# Attachment G

We are writing on behalf of Monterey County Residents for Responsible Development to provide comments on the Final Environmental Impact Report ("FEIR") prepared by Monterey County ("County"), pursuant to the California Environmental Quality Act ("CEQA"),<sup>1</sup> for the California Flats Solar Project ("Project"). The Applicant seeks a Combined Development Permit ("CDP") to develop a 280-megawatt ("MW") solar facility on approximately 3,000 acres of land in unincorporated Monterey County. We previously provided comments on the Draft Environmental Impact Report ("DEIR") for the Project on September 22, 2014.

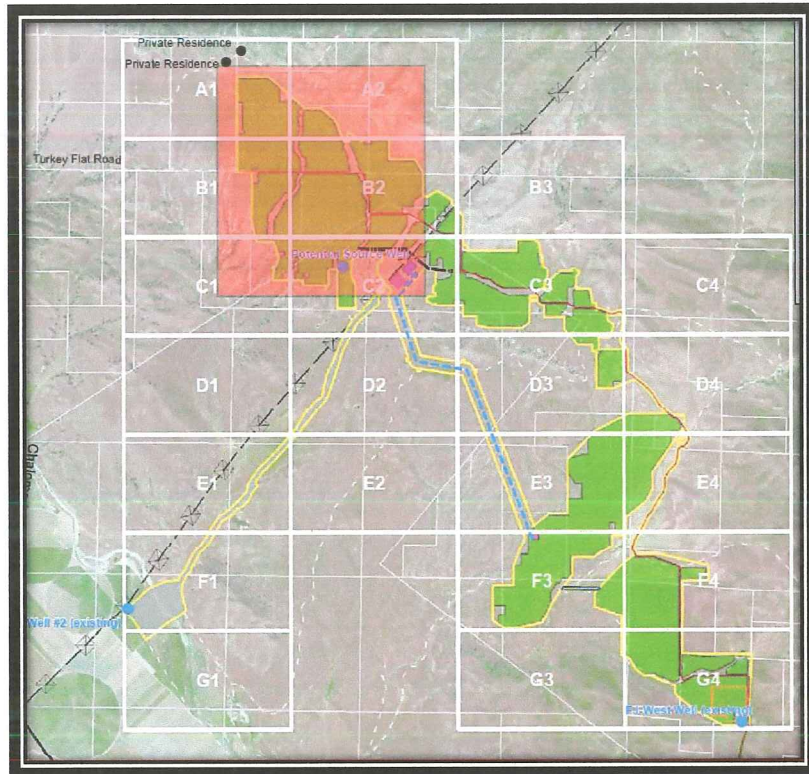
Although the construction phasing is anticipated to occur over 456 work days (Appendix C.1 p. 62), the duration of construction is anticipated to occur over 12 months (Appendix C.1 p. 62). Interpreting this information, we assumed that each construction phase would overlap with some phases of construction occurring concurrently. Therefore, the updated health risk assessment, calculated below, still assumes a construction period of 365 days.<sup>3</sup>

The FEIR states that only 10.3 percent of the solar generating facility area is within one mile of the nearest residential receptor (p. 2-386). Furthermore, the FEIR states that the only construction activities that would occur within a mile of the sensitive receptors are installation of "the solar modules, inverters, and collection systems," and that "actual construction emissions would be more heavily concentrated within the areas of greatest disturbance, such as the substations and switching station..." (p. 2-386). However, the FEIR fails to mention that improvements to the access road, such as widening it by 15 to 30 feet, resurfacing it, paving turnouts for emergency vehicles, etc. would occur throughout the entire Project site, including the section of the site within one mile of the sensitive receptors, and would contribute to DPM emissions (DEIR p. 2-16). Furthermore, a northern substation and a PG&E switching station are anticipated to be located roughly 2 miles away from the sensitive receptors, which were identified by the FEIR as areas with heavily concentrated construction emissions.
